Subject: Contract No. 200-2004-03805, Task 3, Final Draft Report:  
*The Review of NIOSH/ORAUT Procedures and Methods Used for Dose Reconstruction*

**NATIONAL INSTITUTE OF  
OCCUPATIONAL SAFETY AND HEALTH  
ADVISORY BOARD ON DOSE RECONSTRUCTION**

***THE REVIEW OF NIOSH/ORAUT  
PROCEDURES AND METHODS USED  
FOR DOSE RECONSTRUCTION***

Effective Date: 01/17/2005	Revision No. 0	Document No. SCA-TR-Task3	Page No. 2 of 260
-------------------------------	-------------------	------------------------------	----------------------

**Figure 2.1-3. Worker Receiving Radiation Exposure From Posterior Geometry**

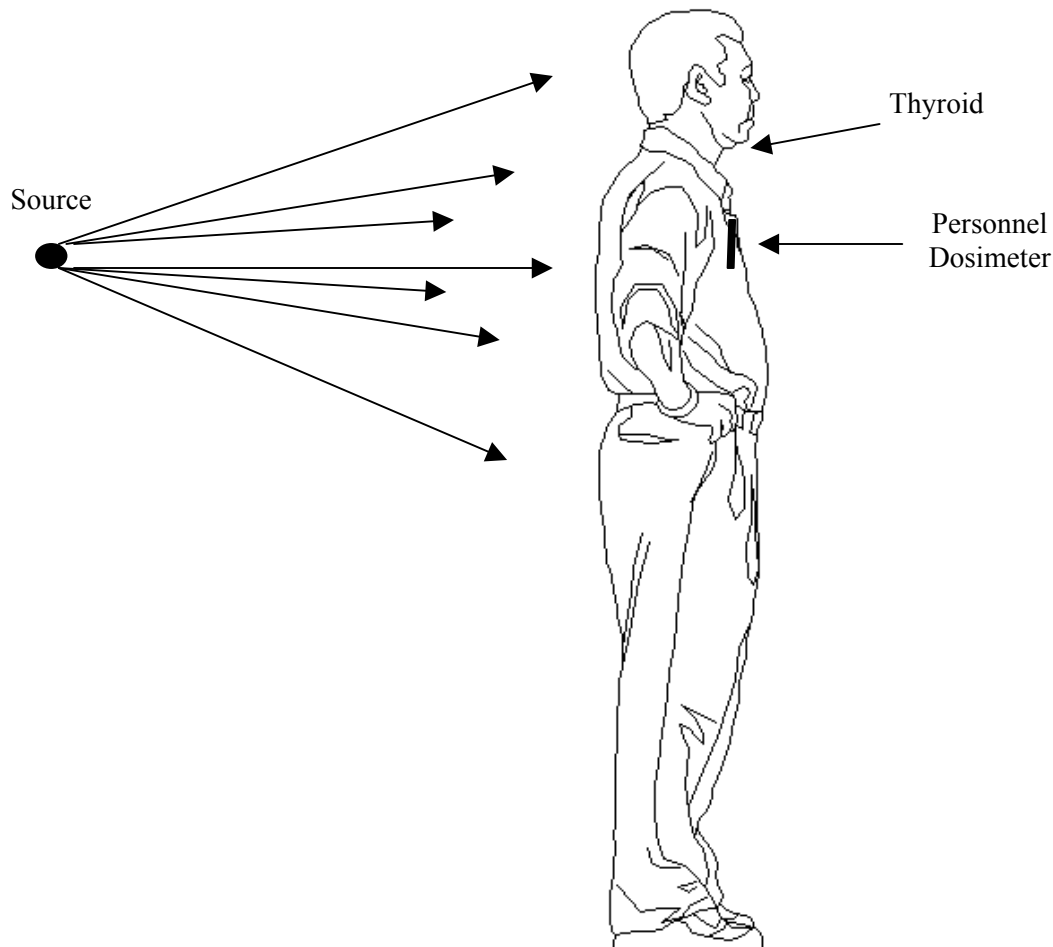
for PA geometry given in Appendix B wrongly assumed that the measured dosimeter dose was worn on the **posterior** of the torso instead of the **anterior**. The consequence of this error would be most pronounced for those tissues/organs that are located at/near the posterior surface of the body (e.g., female breast, male testes, eye, thyroid).

For example, for photons between 30 and 250 keV, Appendix B gives a thyroid  $DCF_{PA}$  value of 0.298 rem for a recorded deep dose ( $H_p(10)$ ) of 1 rem. If the recorded deep dose involved a dosimeter (either film or TLD) worn on the chest, the assigned thyroid  $DCF_{PA}$  of 0.298 is in error, as shown in the diagram below:

- (1) the personnel dosimeter received radiation that is attenuated by the full thickness of the chest
- (2) the thyroid receives radiation that is attenuated by tissues that are limited to the neck
- (3) additionally, tissues/organs within the body would also receive exposure from **backscatter**, which would **not** be recorded on an anterior-worn dosimeter that is subjected to a PA exposure geometry

If this interpretation is correct, than  $DCF_{PA}$  values for **all** tissues should be  $\geq 1.0$  with the highest  $DCF_{PA}$  values for (1) low-energy radiation and/or (2) tissues/organs located near the posterior portion, since these tissues are subject to a beam that is **least** attenuated and subject to a maximum backscatter.

**Figure 2.1-4. Ratio of  $H_E$  to  $H_P(10)$  as a Function of Photon Energy**

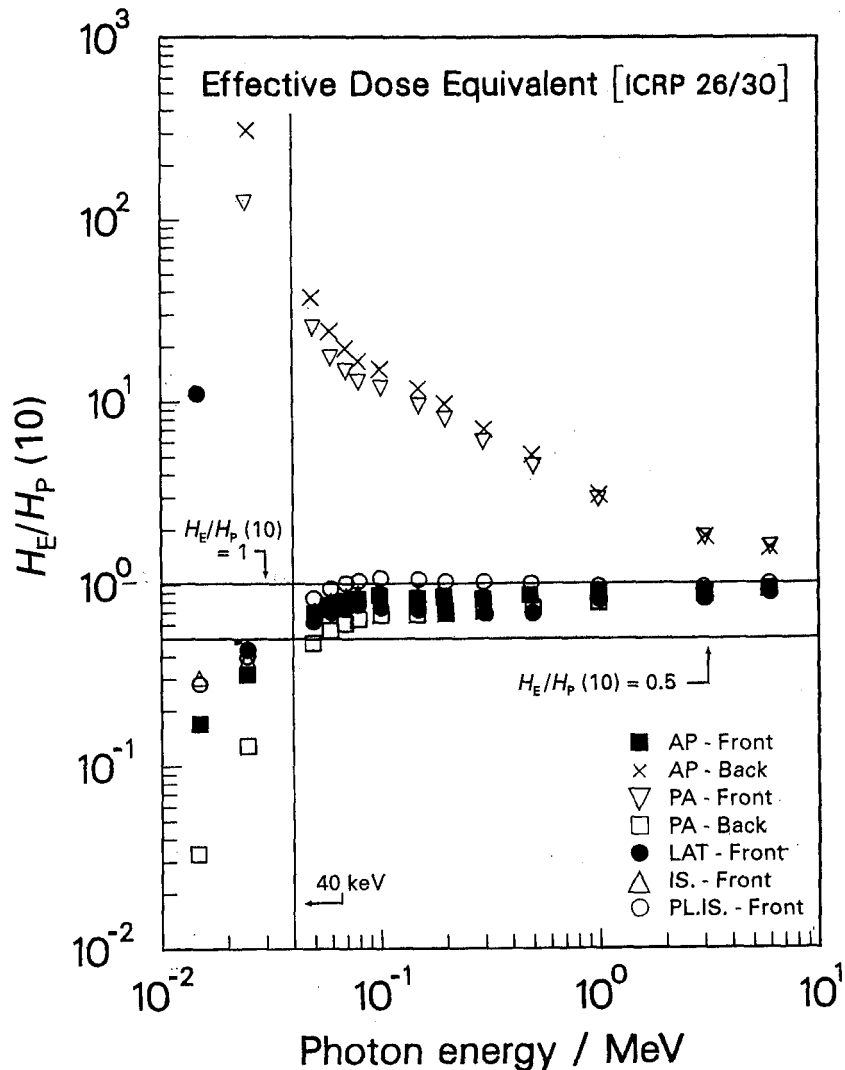
The critical difference in the  $H_E/H_P(10)$  coefficient for a dosimeter that **in fact is worn on the front**, but is wrongly assumed to have been worn on the back, is dramatized by comparing the curves represented by  $\square$  and  $\square$ . The difference is most pronounced for low-energy and low-penetrating photons. For example, for 30 keV photons in cases in which the dosimeter is worn on the back, the coefficient is about 0.14; when the dosimeter is worn on front, the  $H_E/H_P(10)$  coefficient is about 100, or nearly 1,000 times higher.

As previously stated and verified in Figure 2.1-4, for all photon energies, the ratio of organ dose to recorded  $H_P(10)$  must be greater than unity when the recorded dose was measured on the body's anterior and when exposure corresponds to a PA geometry.

**Figure 5.2-1**

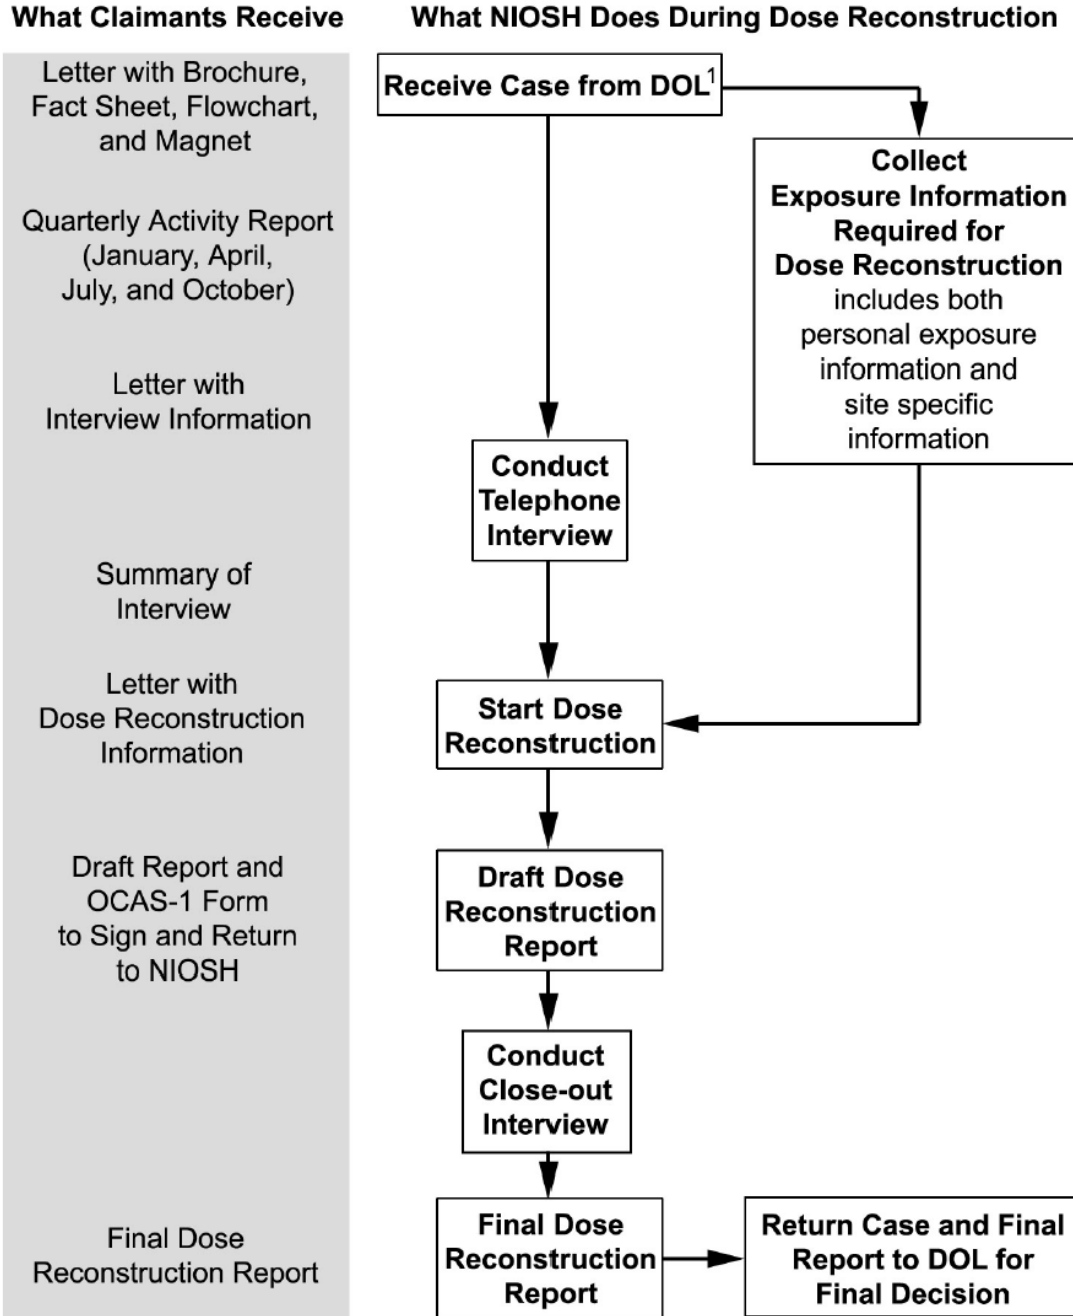
The flowsheet (see Figure 5.2-1 on page 5-5) indicates that dose records are collected in parallel with the interviews. Hence, no connection appears to exist between the two steps. Further,
